Flide Street, Caringbah, Affordable
Housing

SSD-84862461

Submissions Report

Prepared For: Homes NSW

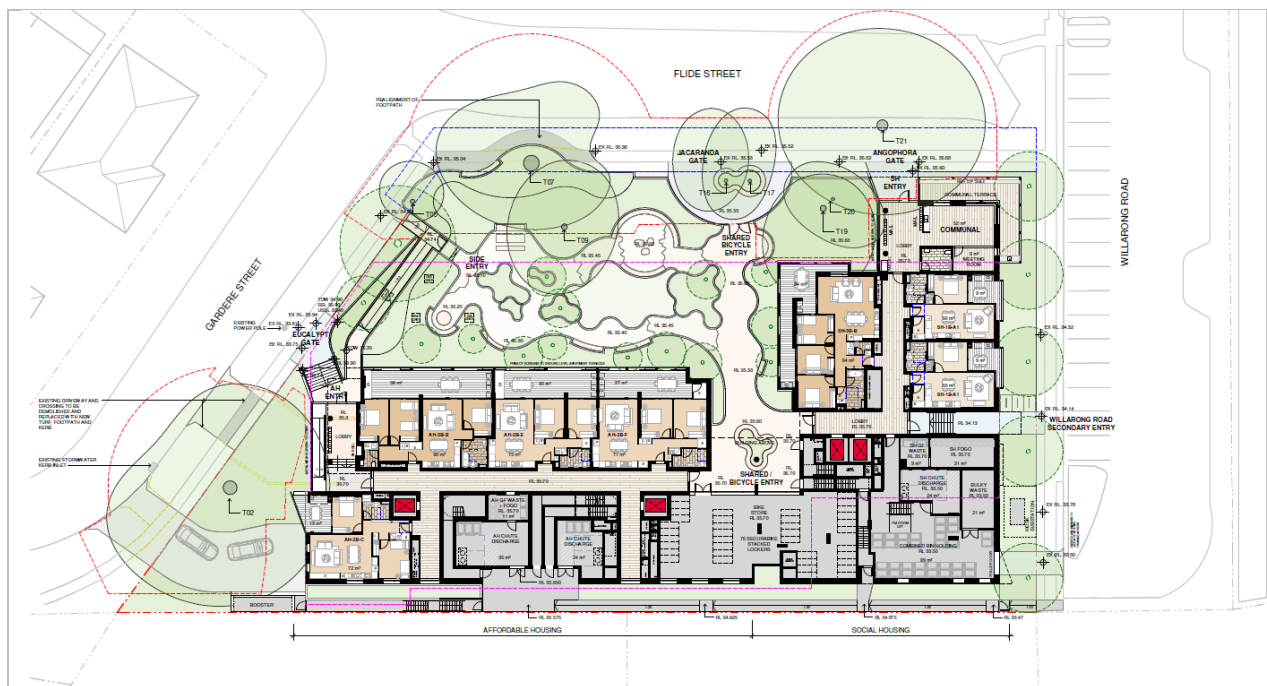
The fire booster assembly relocated from the south west corner of the Site to within the building footprint along Gardere Street.	Relocation of driveway has allowed design refinement and integration with building design.
Bench seat and clerestory window added adjacent to the SH lift lobby	Design refinement.
Bench seat and clerestory window added adjacent to the Social Housing Building lift lobby	
Removal of one (1) x 1 bed apartment (relocated to Level 14).	Reconfiguration of Upper Ground Level 01 to accommodate driveway access from Willarong Road.
Bicycle store reduced from 76 lockers to 32 plus 15 introduced to Basement level 00 (Total lockers = 47).	
Existing secondary pedestrian entry into the Social Housing lobby via Willarong Road has been removed and replaced with bin store entry.	Refer to Bates Smart Response to Submissions (RTS) report at Appendix C, for further justification and alternative designs considered for these changes.

Bin store has been relocated

Figure 1 Comparison Driveway Entry – SSDA vs RTS (Source: Bates Smart)

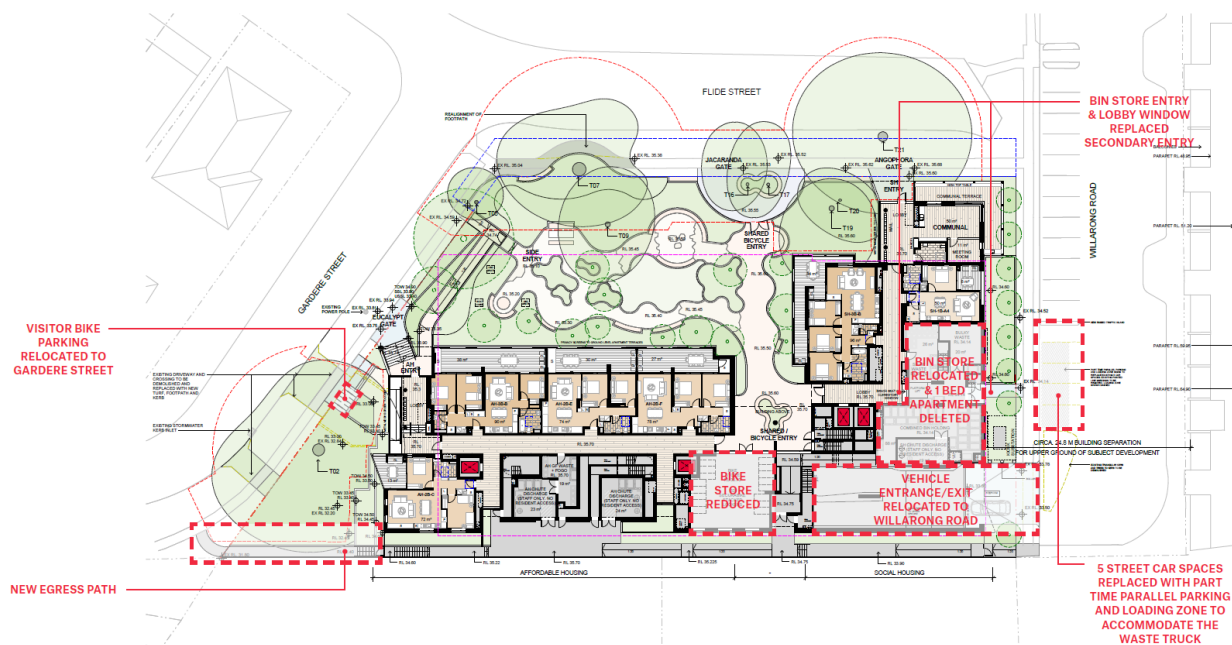
As outlined above, majority of the changes made since exhibition are in relation to the relocation of the driveway access from Gardere Street to Willarong Road. This change is to address TfNSW feedback and DPHI request for vehicle access to be via Kingsway /Willarong Road intersection.

The driveway is positioned at the south of the Site which is the optimum location given the Site slopes down toward the rail corridor and thus reduces the need for excavation and ramp lengths consistent with Objective 3H-1 of the Apartment Design Guide (ADG). This has required reconfiguration of the basement and ground floor plane including landscaping. These changes are shown in the Figure 1 and Figure 2, Appendix C, and discussed further below.

Direct conflict with the new driveway location has necessitated review of the secondary pedestrian access to the Social Housing Building from Willarong Road, bins store, parking and operational waste management. To address this conflict two options were explored:

Figure 4 Compare of Shadows Diagrams – 360 Kingsway (Source: Bates Smart)

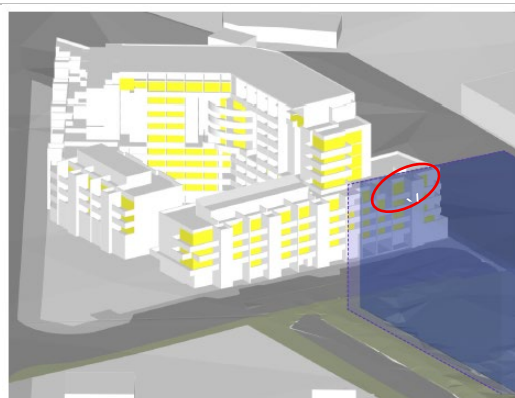
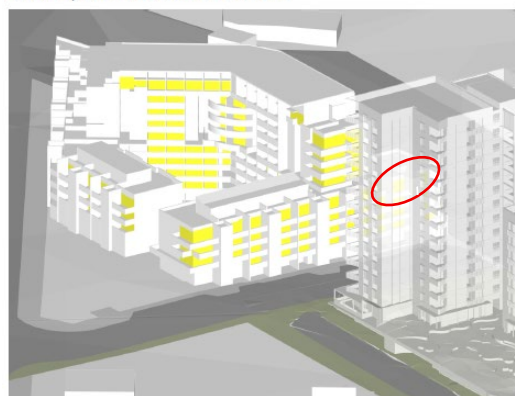
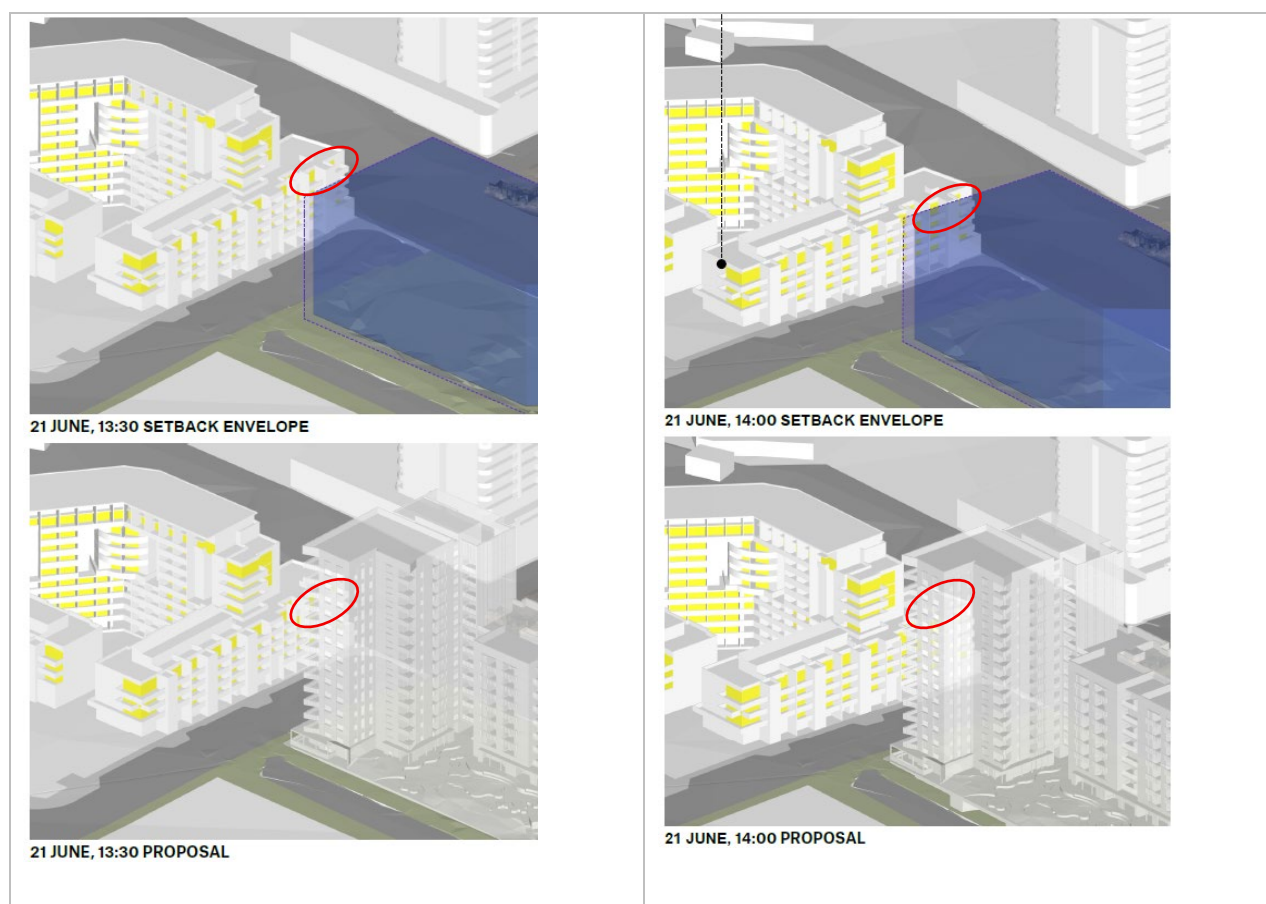
Submission Reference	Matters Raised	Response
Rezoning		
DPHI_01	The height sought under the proposed rezoning would result in overshadowing impacts, particularly to podium units of 360 Kingsway (Meriton). Please provide comparative analysis illustrating the extent of overshadowing from a compliant design.	Shadows of compliant vs proposed building envelope has been undertaken by Bates Smart in Appendix C. Further assessment is provided in Section 4.5.
Traffic and Access		
DPHI_02	Amend the proposal to direct all vehicle access via the Willarong Road cul-de-sac, which connects to a signalised intersection at The Kingsway/Willarong Road, allowing for all movements under signal control If an alternative access arrangement is proposed, please consult with Transport for NSW (TfNSW) to address concerns regarding cumulative traffic impacts and road safety.	The proposal has been amended to direct all vehicle access via the Willarong Road/ The Kingsway intersection as requested. This arrangement is further considered in Section 4.5.1 and TTPP's Transport Impact Assessment at Appendix E. No alternate access arrangements are proposed.

The comparison shows that while there is some additional overshadowing, only two apartments (shown in red outline) of 51 apartments that were assessed in the EIS as not receiving 2 hours of solar access (proposed scenario) would have received a minimum of 2 hours between 9am and 3pm mid-winter under a compliant building envelope scenario (see Figure 4).

Notwithstanding this impact, the proposal continues to comply with the Apartment Design Guide (ADG) requirement that at least 70% of apartments within the affected development receive a minimum of two hours of direct sunlight between 9.00am and 3.00pm at mid-winter, achieving 71.3% compliance under the proposed scheme.

Figure 5 Impact on Proposal to Mitigate Incremental Impacts of Proposed Height Control

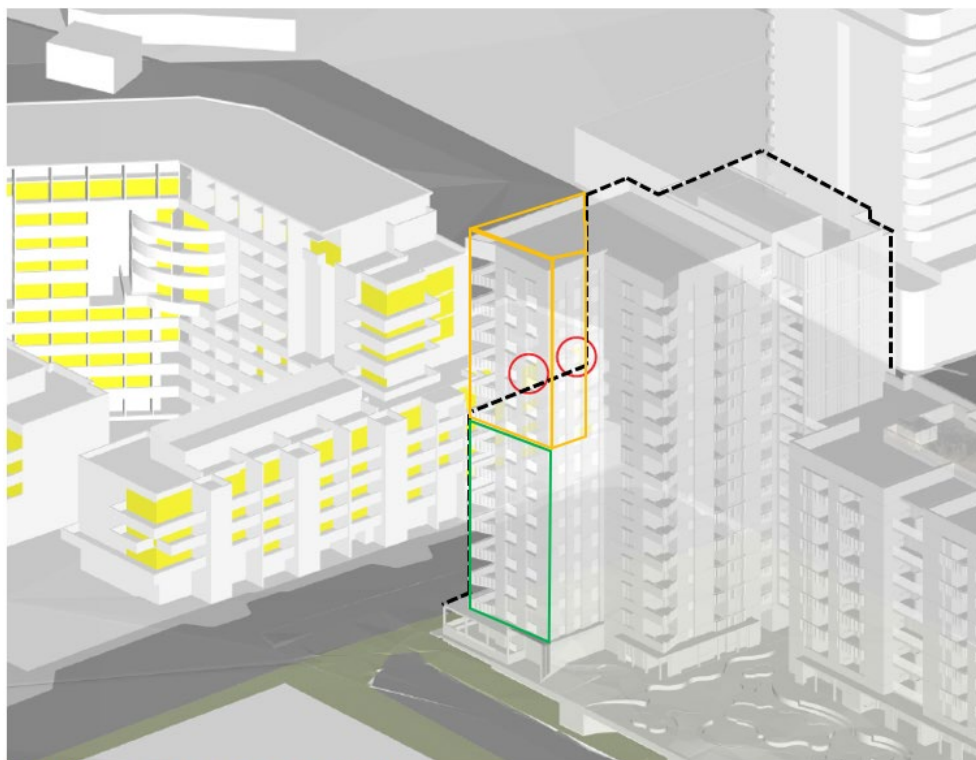
Crucially, maintaining full solar access compliance for the two affected apartments would necessitate a substantial redesign, resulting in the loss of approximately 12 affordable housing dwellings. This is demonstrated in Figure 5 with the orange outline representing the impact to the proposed envelope. Level 8 would be the last level and Level 9 becomes the roof/parapet. Consequently two (2) apartments per floor from Level 9 to Level 14 would be deleted. This outcome would directly undermine the core objectives of the Housing SEPP, which seek to maximise the delivery of affordable housing, particularly in locations with excellent access to public transport, services, and employment opportunities such as Caringbah.
